# LANDSCAPE & TREES

# LANDSCAPE & TREES

# Incompetent Landscape Impact Assessment

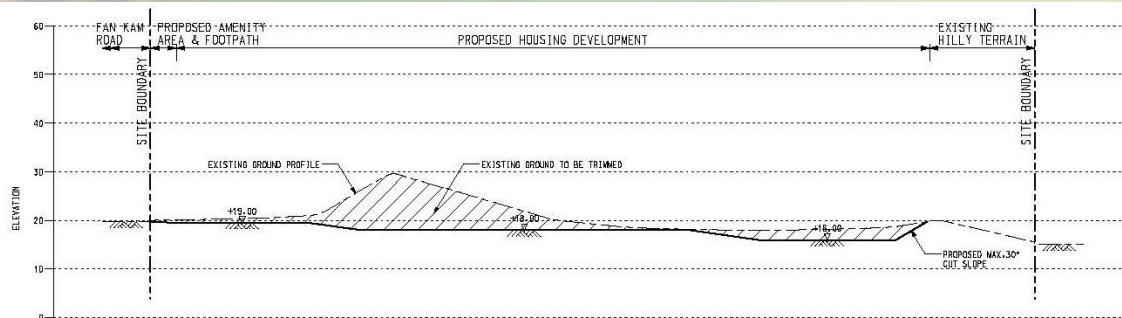
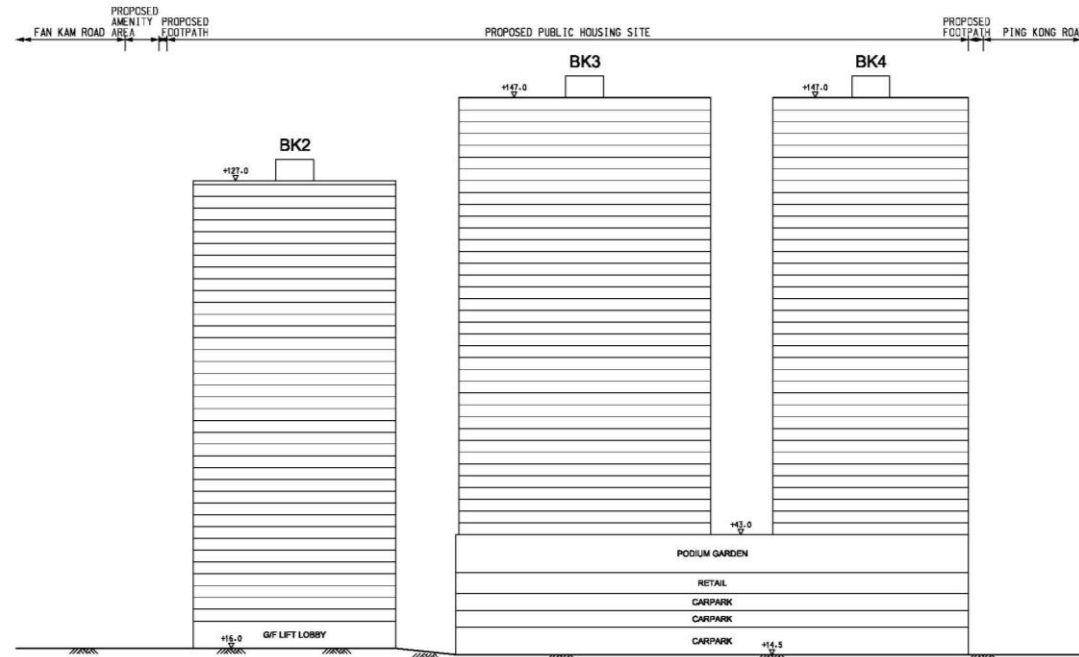
- This EIA Plan shows the “Conceptual Landscape And Mitigation Plan” (Fig. 11.9.2)
- Mitigation Measure “CM1 – Preservation of Existing Vegetation” is indicated on plan.
- Are sections provided to explain methods of tree retention?

- There are no cross-sections provided to demonstrate the practicality of the tree retention proposals.

## Example 1: TPI T786 [T57] [*Ficus virens*]

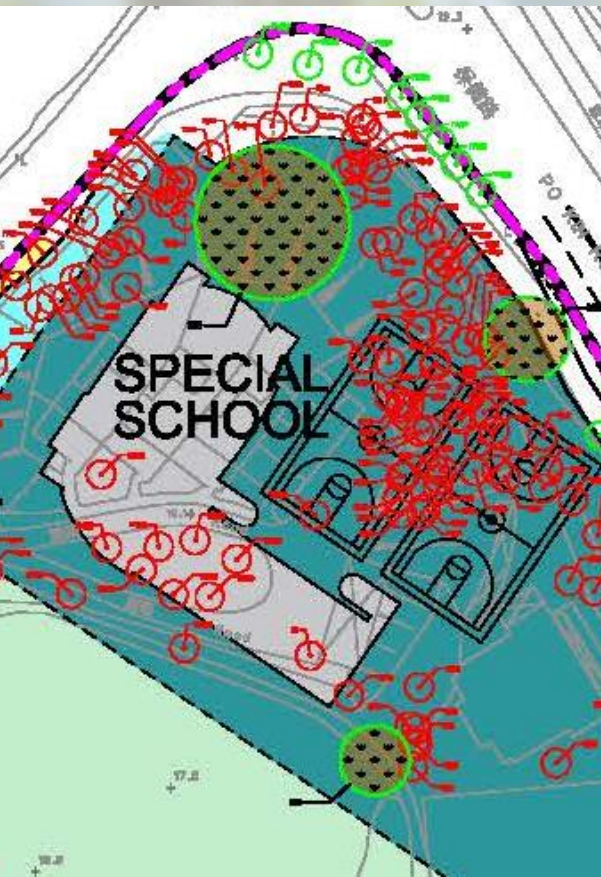
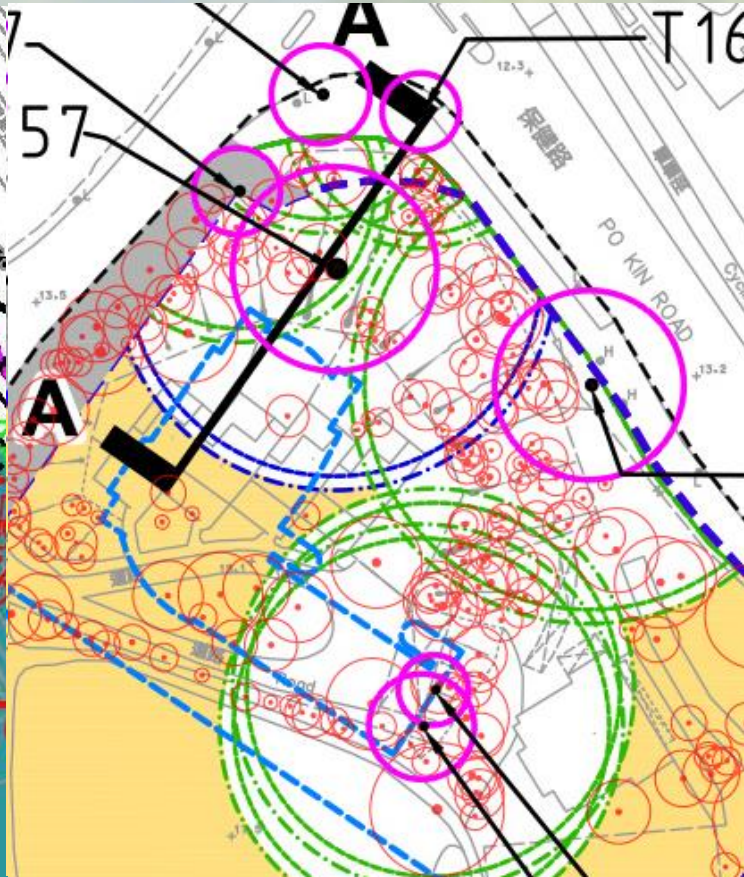
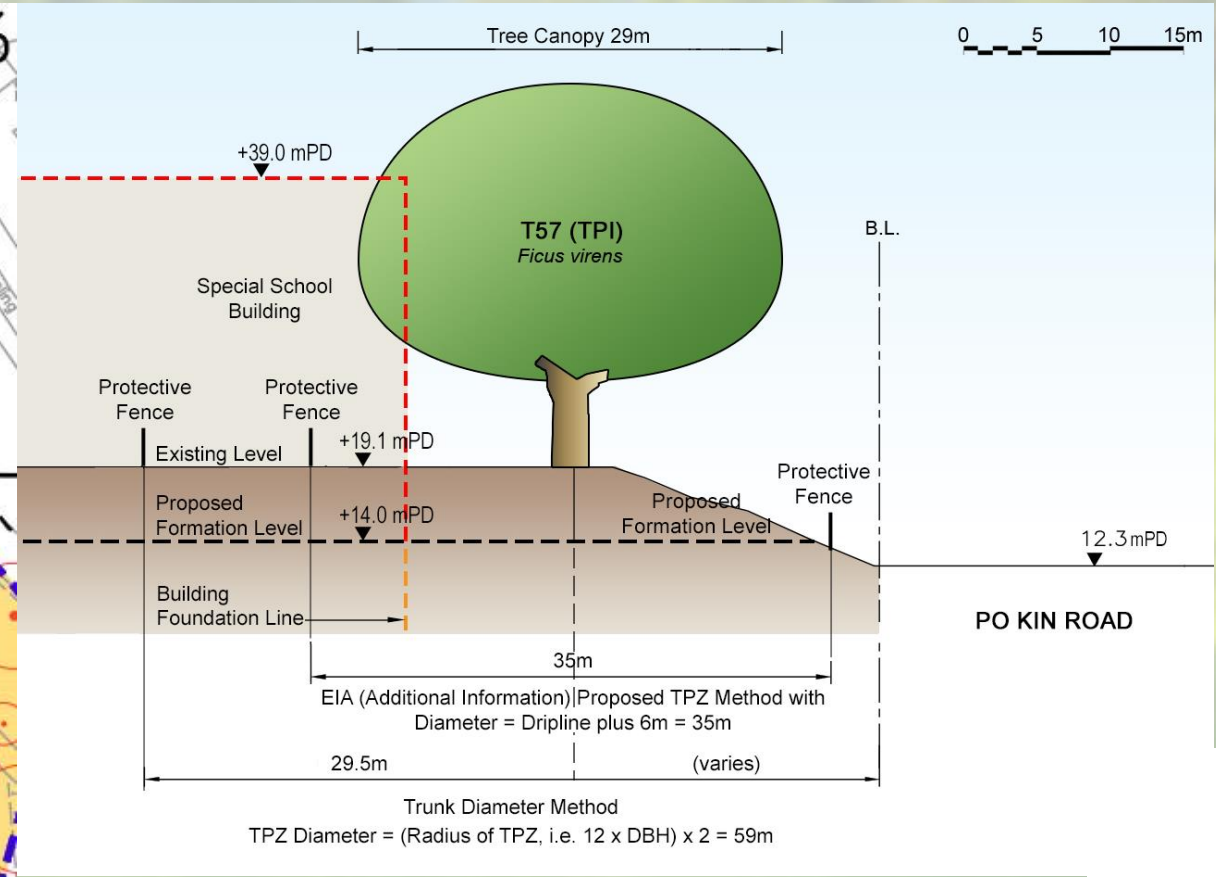
The plan below left is from the EIA (with **wrong canopy dimension & no TPZ shown**)

The plan below middle is from the URBIS Tree Survey Audit showing the correct tree dimensions and appropriate TPZ according to the GLTMS Guidelines. It can also be seen clearly that two other nearby pOVTs (that were **wrongly omitted** from the EIA Tree Survey) also clash with the special school building.

Special School Building clashes with TPI T57

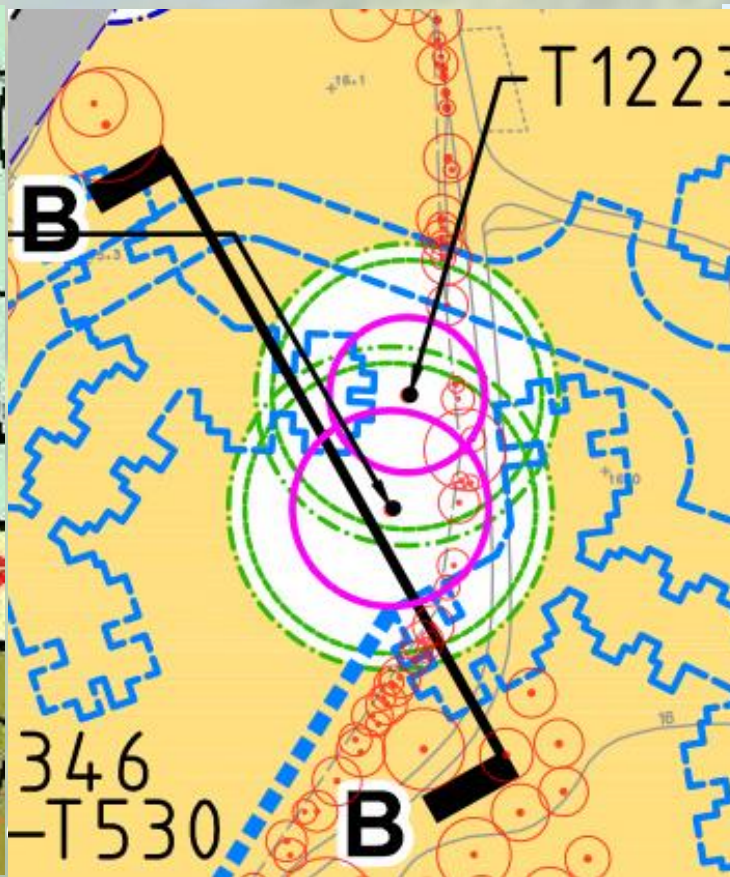
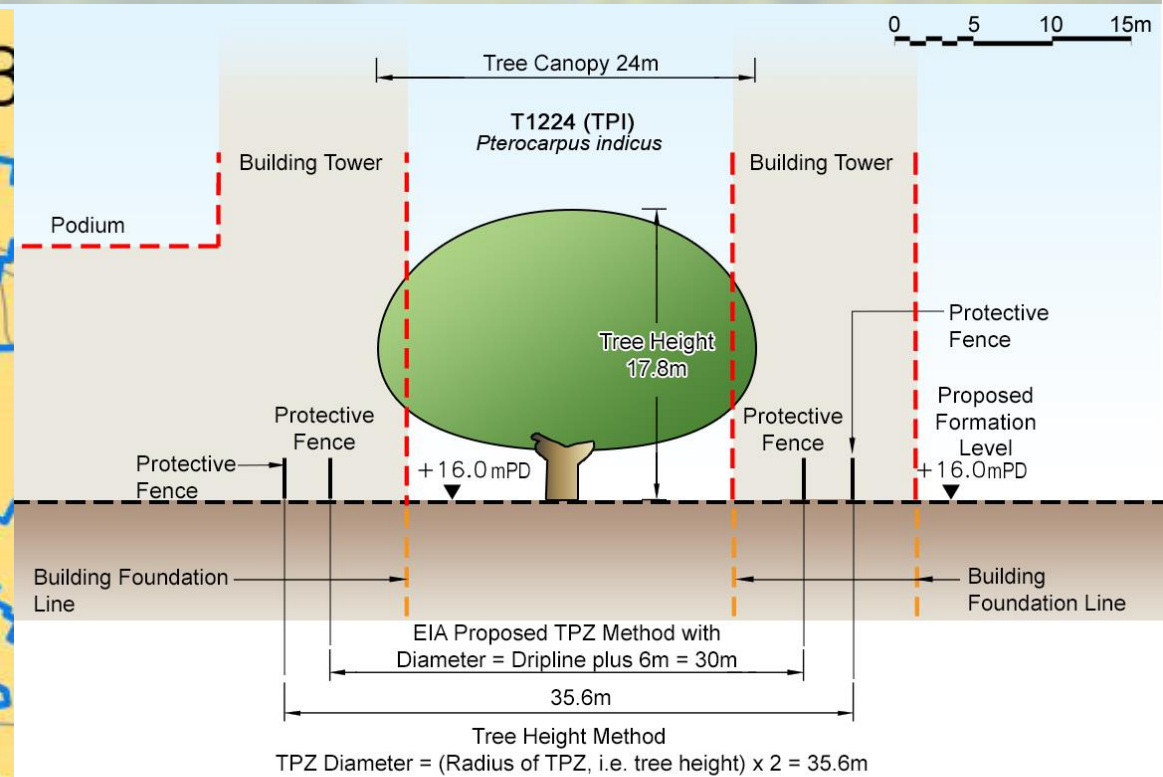
The plan below left is from the EIA (with **wrong dimension & no TPZ shown**)  
The EIA tree canopy dimensions are far too small

The section below right shows the serious clash between TPI T36 and the proposed residential block that renders it impossible to retain this pOVT.

Special School Building clashes with TPI T786

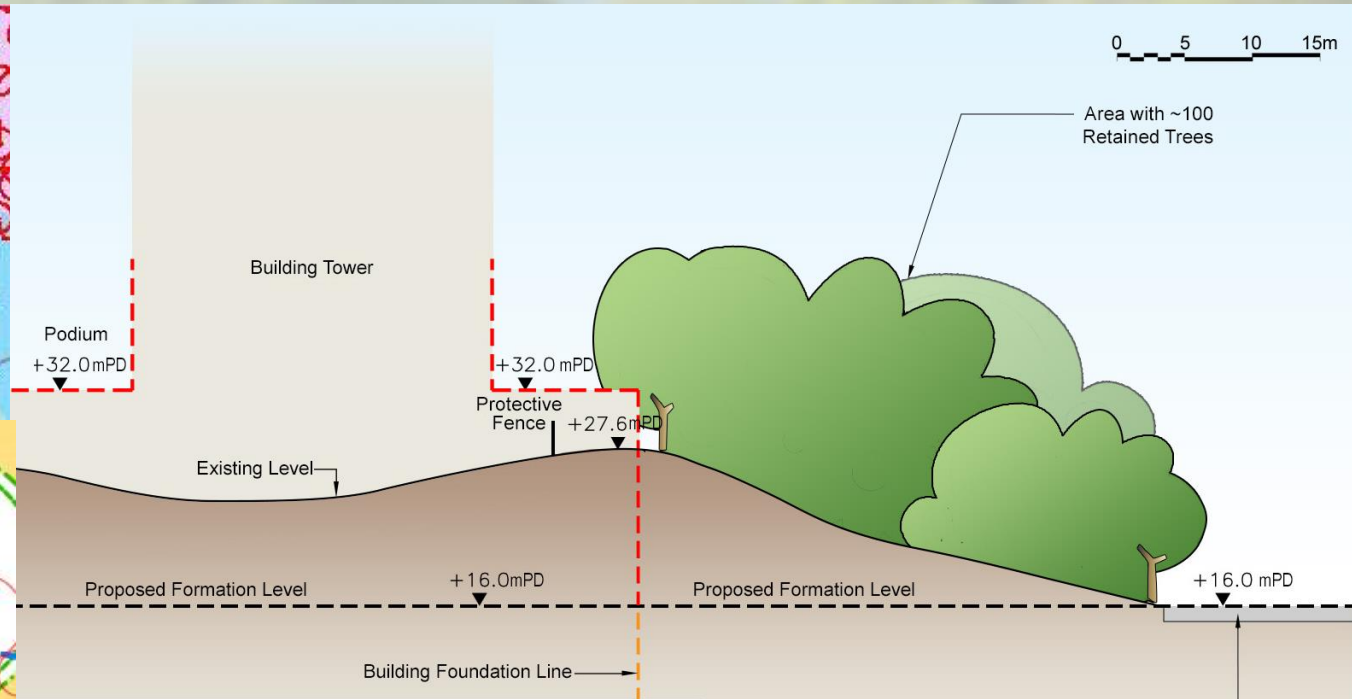
The plan below left-top is from the EIA (with **no retaining walls, cut slopes or TPZ shown**)

The plan below left-bottom is from the URBIS Tree Survey Audit. It illustrates that the TPZs necessary for the 4 pOVTs between Buildings 6 & 12 clash with those buildings.

The section below right shows the big level difference between the existing and proposed ground levels. The proposed formation level requires removal of the entire tree cluster.
